**INSTRUMENT
APPROACH
CHART**

GWANGJU/Gwangju(RKJJ)
ILS/DME
RWY 04R

Change : Information of instrument approach procedure for RWY 04R.

GWANGJU/Gwangju(RKJJ)
ASR
RWY 04L

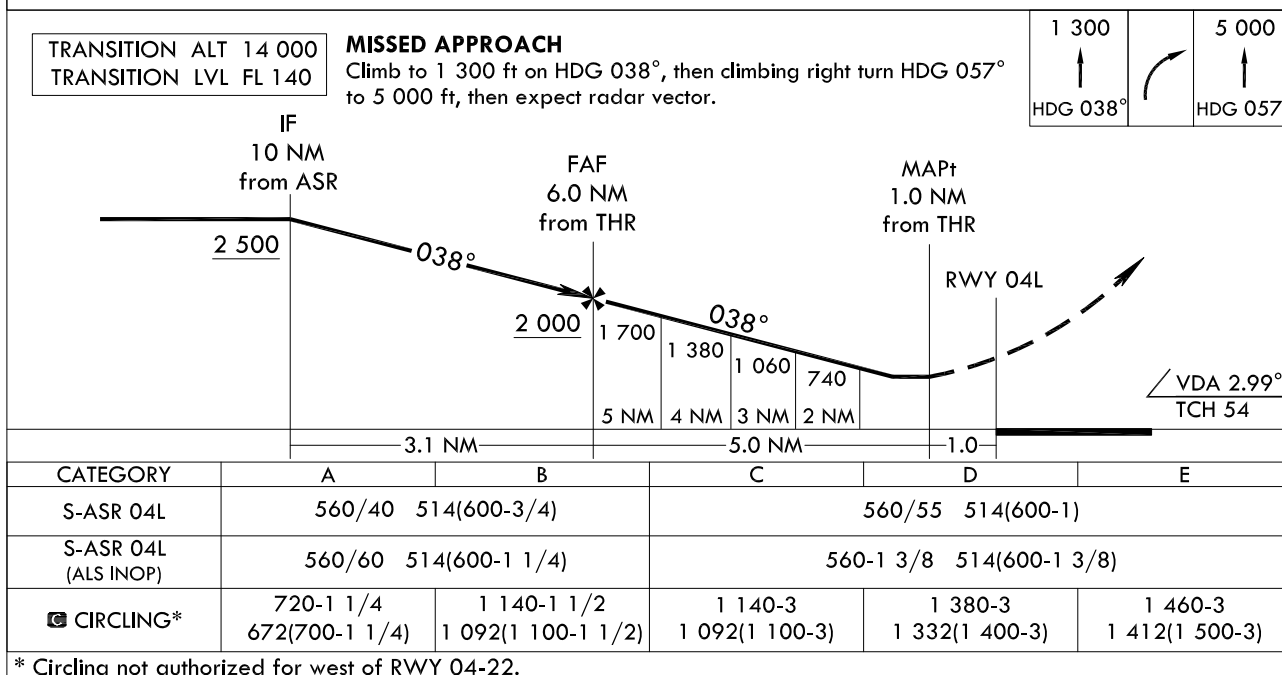
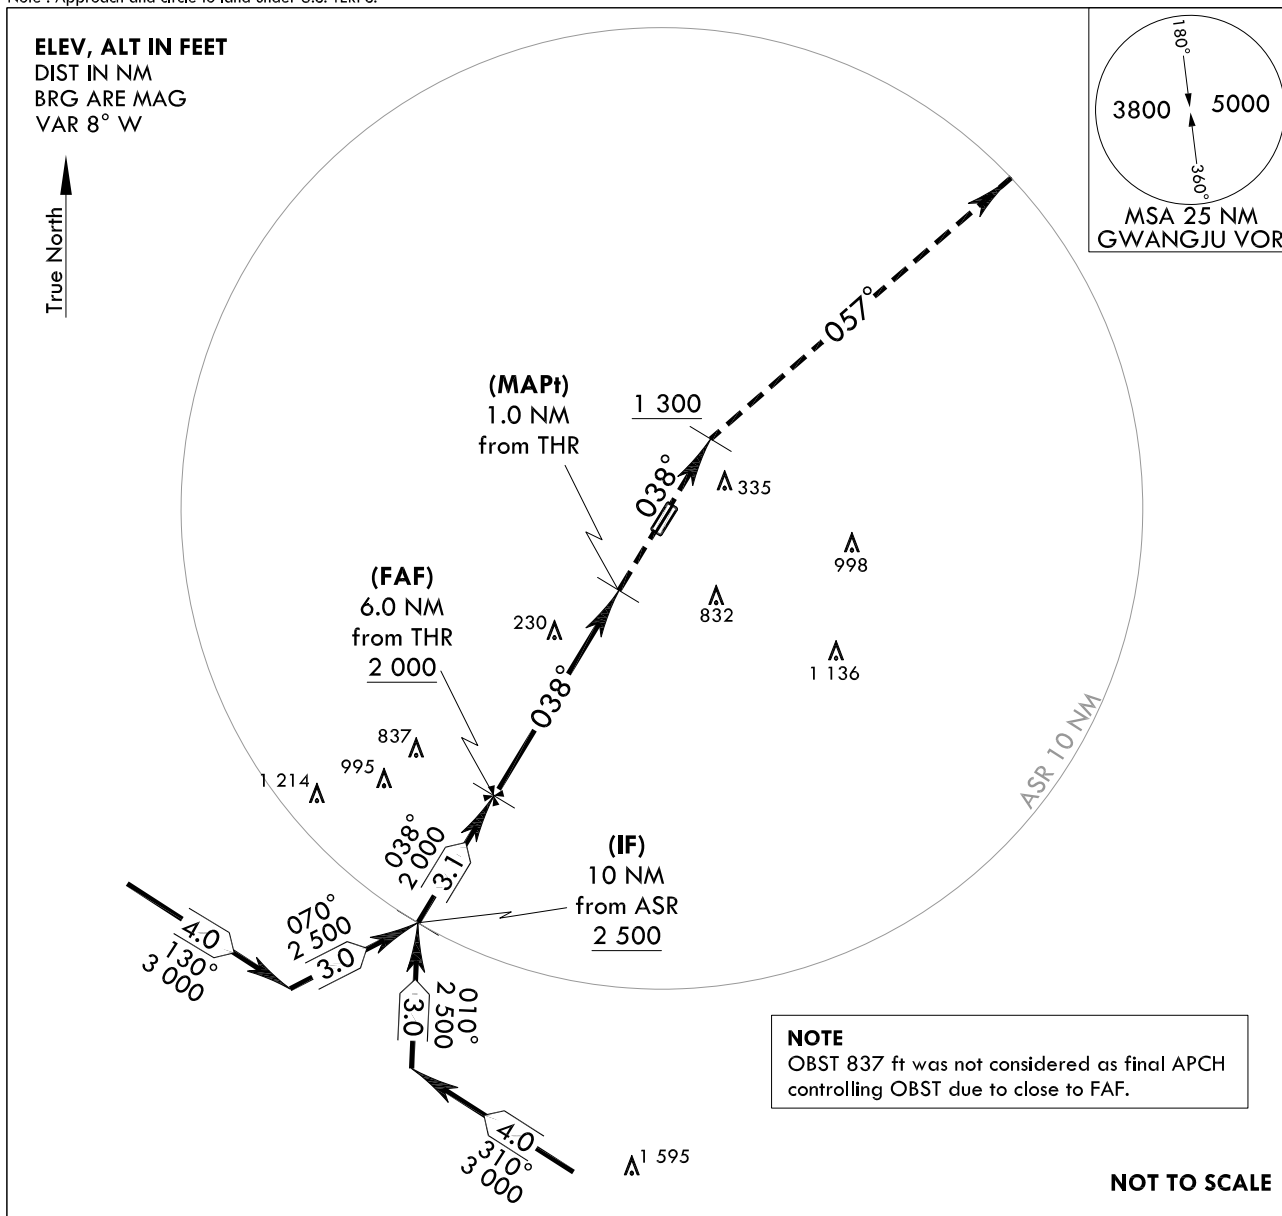
Change : Information of instrument approach procedure for RWY 04L.

GWANGJU/Gwangju(RKJJ)
LOC/DME
RWY 22L

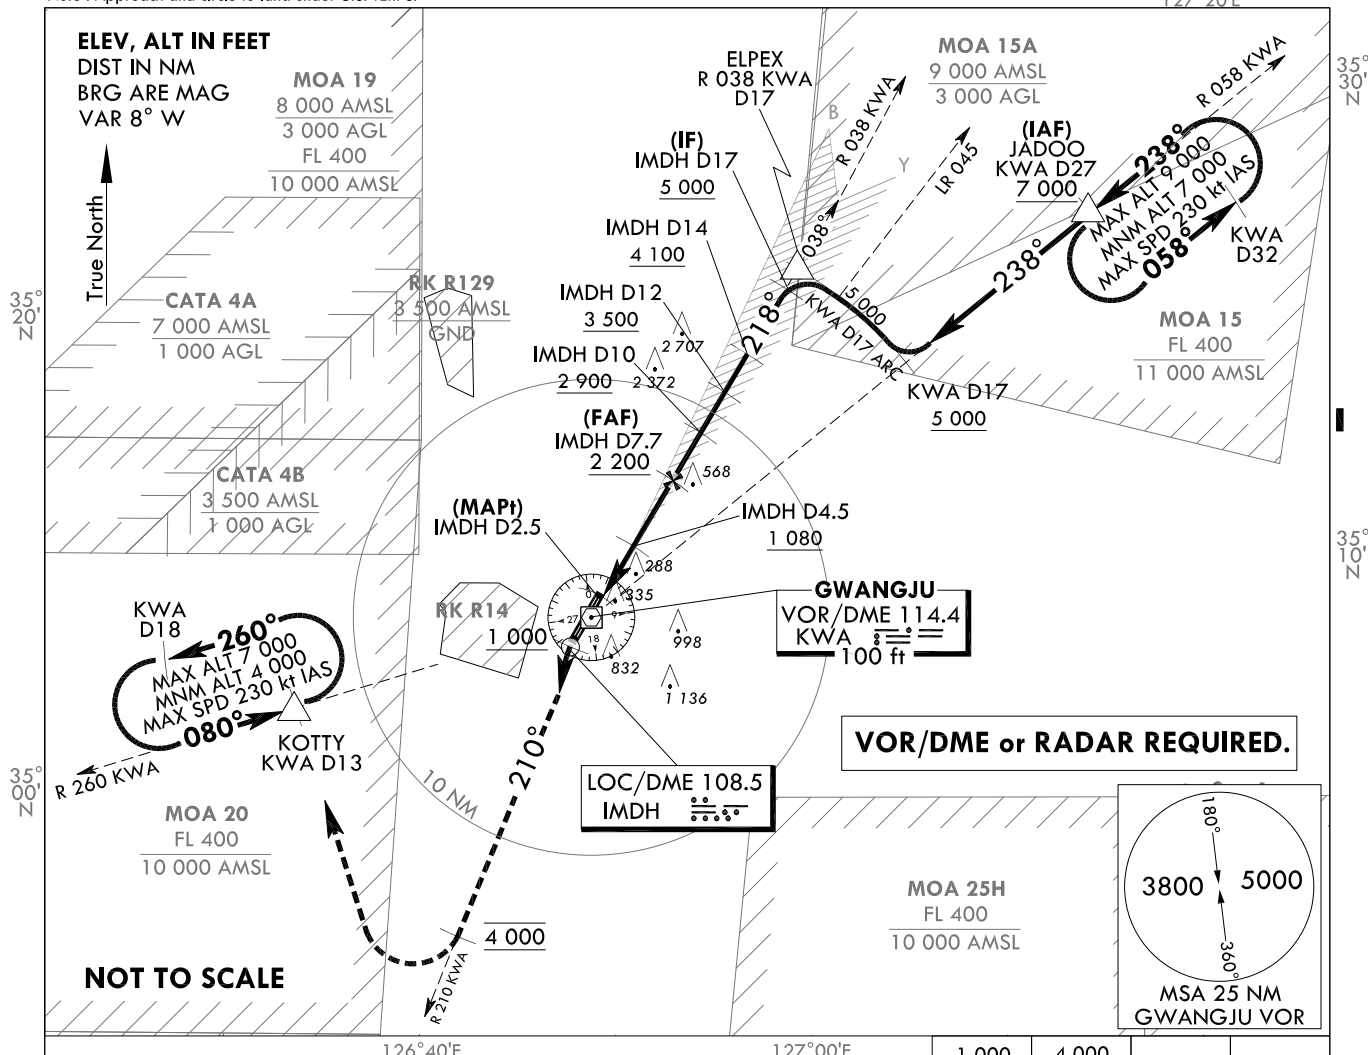
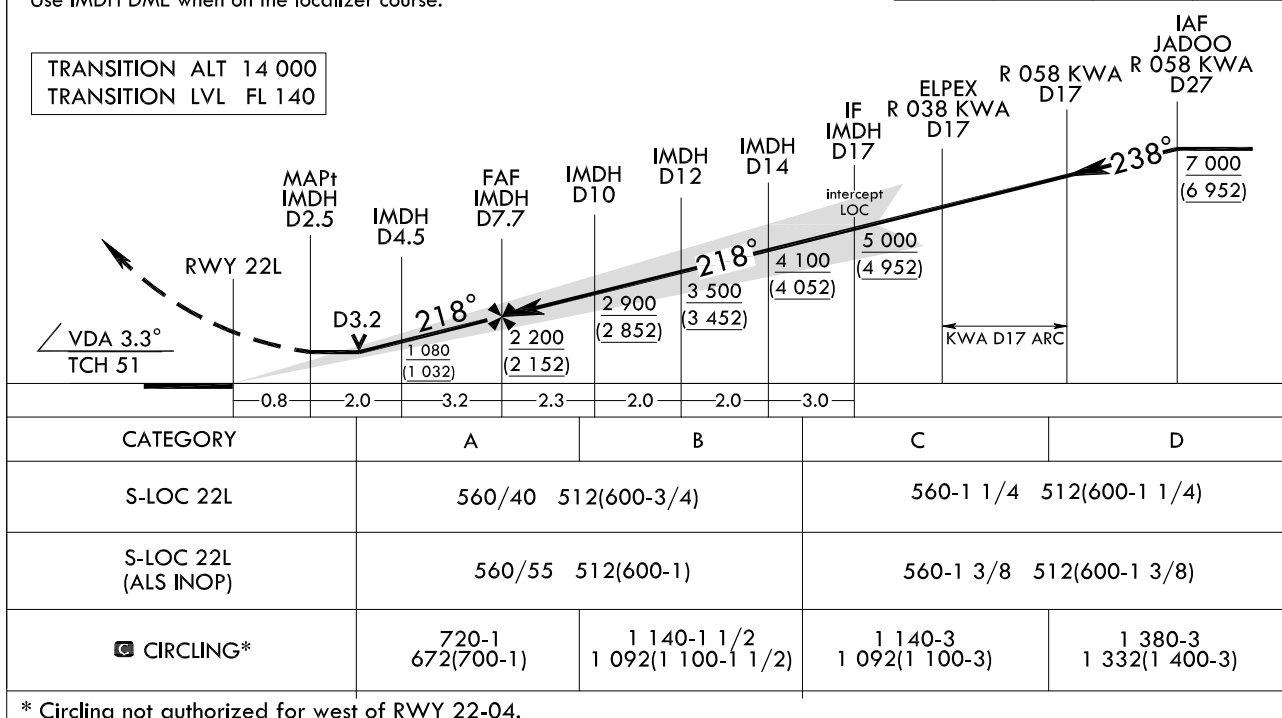
Change : Amended phrase for ELPEX radial(R 308 → R 038) and Information of KWA D17 ALT limitation(3 500 → 5 000).

**GWANGJU/Gwangju(RKJJ)
VOR/DME
RWY 22L**

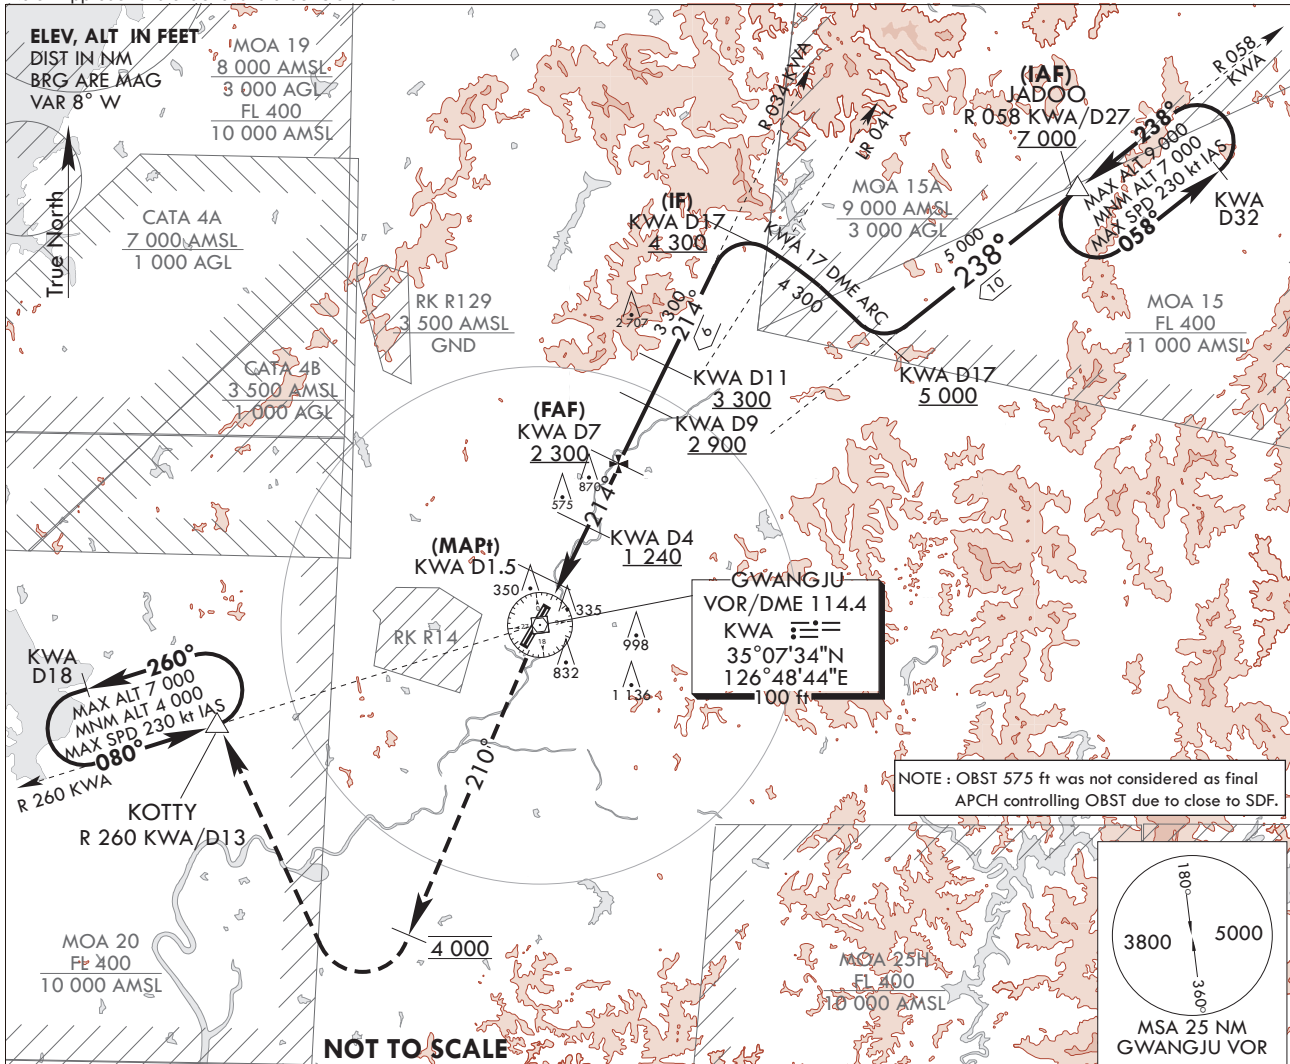
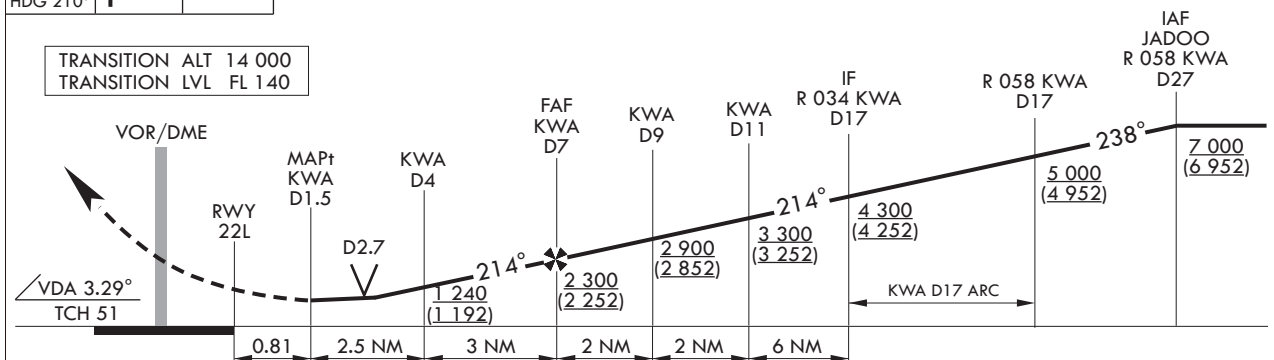
Change : Information of instrument approach procedure for RWY 22L.

GWANGJU/Gwangju(RKJJ)
ASR
RWY 22L

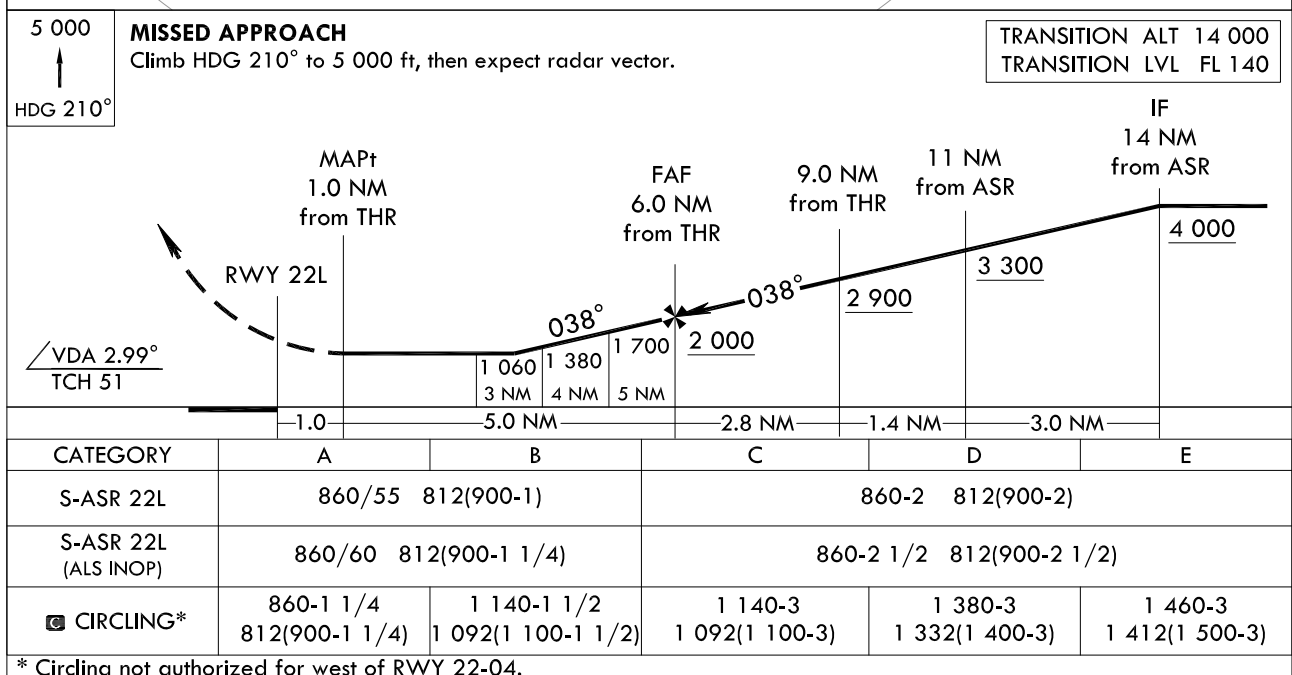
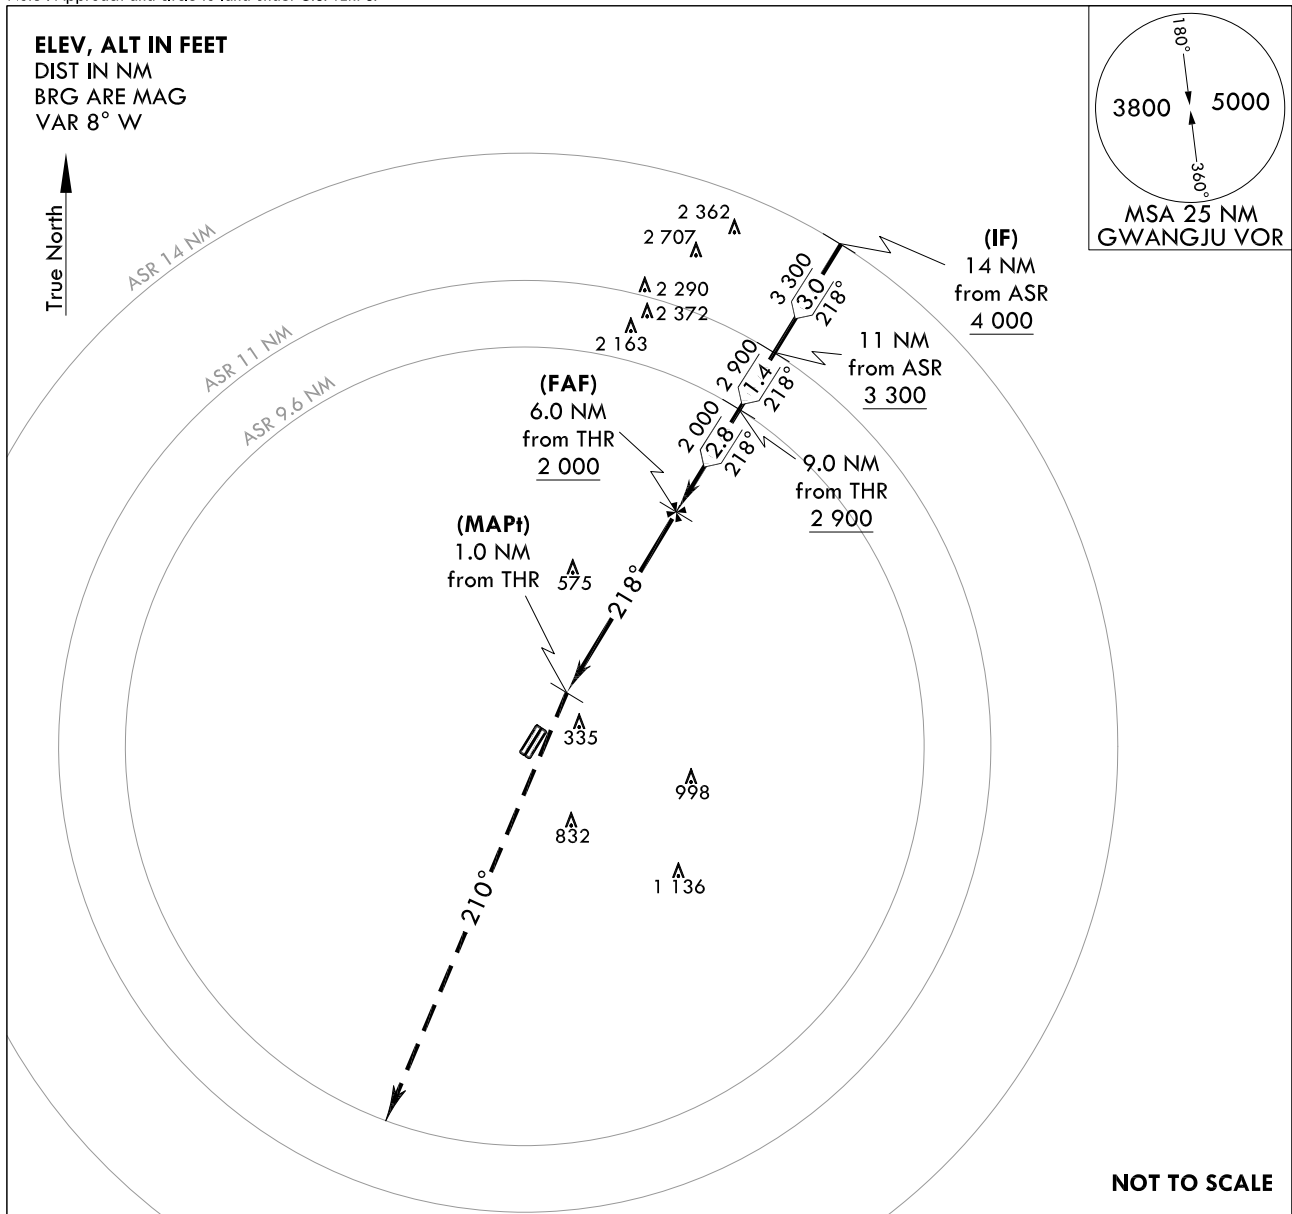
Change : Information of instrument approach procedure for RWY 22L.

**GWANGJU/Gwangju(RKJJ)
VOR/DME
RWY 22R**

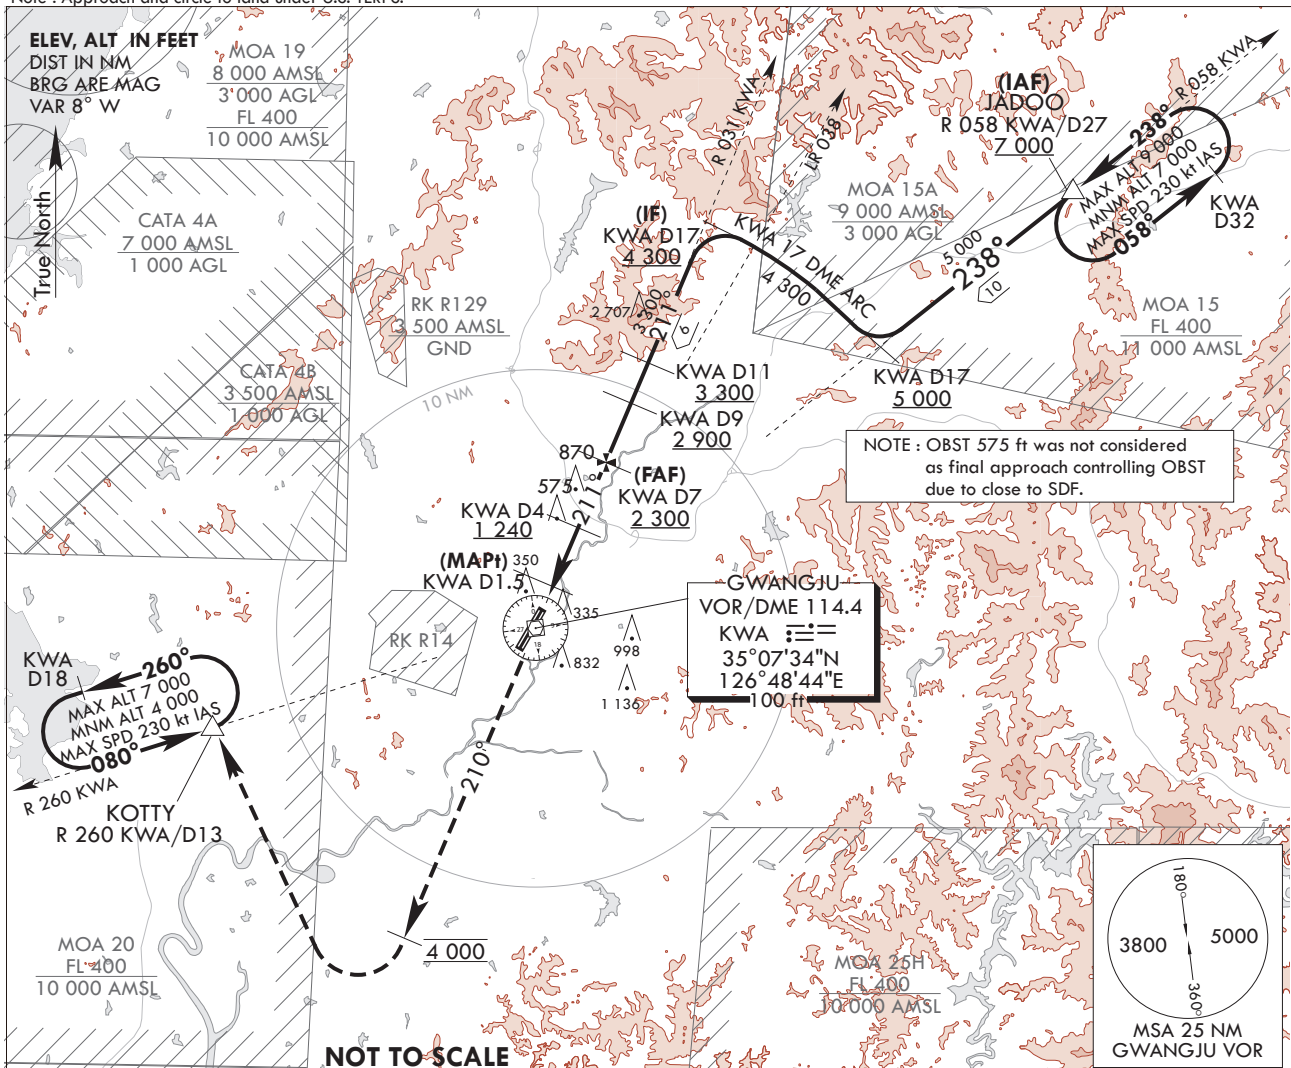
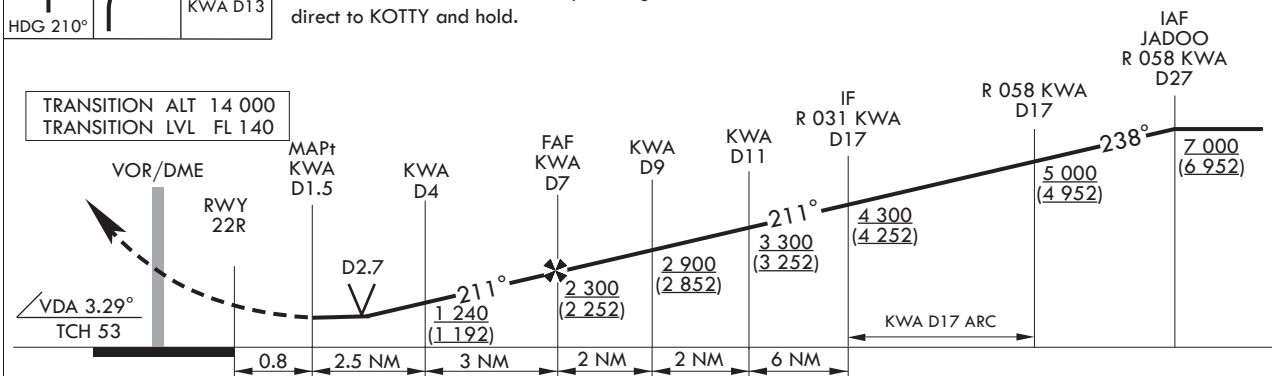
Change : Information of instrument approach procedure for RWY 22R.
